REMARKS

**Annotated Drawing
Sheet**

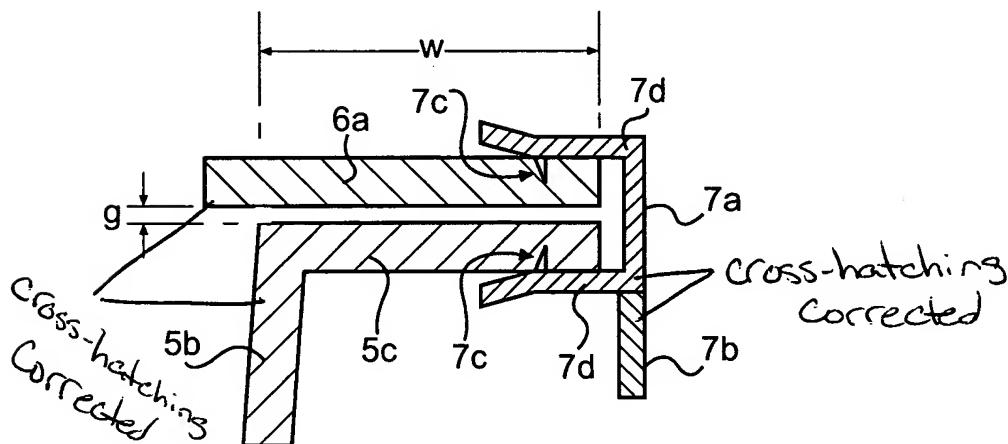
The Examiner objected to Figure 2a, stating that it lacks proper cross-hatching indicating the type of materials comprising the embodiment of the invention depicted in Figure 2a. Applicants submit the attached replacement Figure 2a, addressing the Examiner's objection. Applicants also submit the attached annotated drawing sheet reflecting the changes made in replacement Figure 2a. Applicants believe the replacement Figure 2a overcomes the Examiner's objection and requests approval of the replacement figure.
